Model: SP5/SP5L LCT		Date: 15-Mar-99	No.: MA698001
Modified Article: Relay Connector for the Main Frame		Prepared by: A. Sasaki	
From: Technical Service Dept., GTS Division			
Reason for Modification:	<input checked="" type="checkbox"/> Parts catalog correction	<input type="checkbox"/> Vendor change	<input type="checkbox"/> To meet standards ( )
	<input type="checkbox"/> To facilitate assembly	<input type="checkbox"/> To improve reliability	
	<input type="checkbox"/> Part standardization	<input type="checkbox"/> Other

### 5. Electrical Section (A698)

Model: SP5/SP5L/Mojito LCT	Date: 15-Jul-99	No.: MA698002a
----------------------------	-----------------	----------------

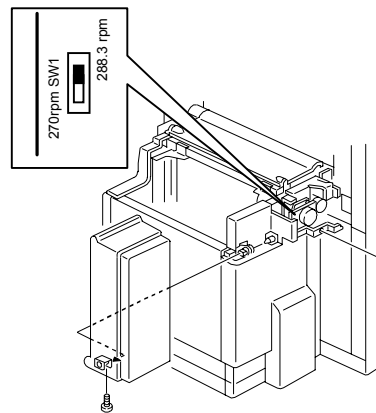
**To allow this LCT (RT37) to be installed on a new model (Mojito A292/A293), the motor has been changed because the A292/A293 model has a faster process speed.**

**The new motor can be used on both models, A229 and A292/A293, but the DIP switch has to be changed to the upper position (288.3 rpm) as shown when the RT37 is installed on the A292/A293. The factory setting is the lower position.**

**A292/293: Upper position**  
**A229: Lower position (factory setting)**
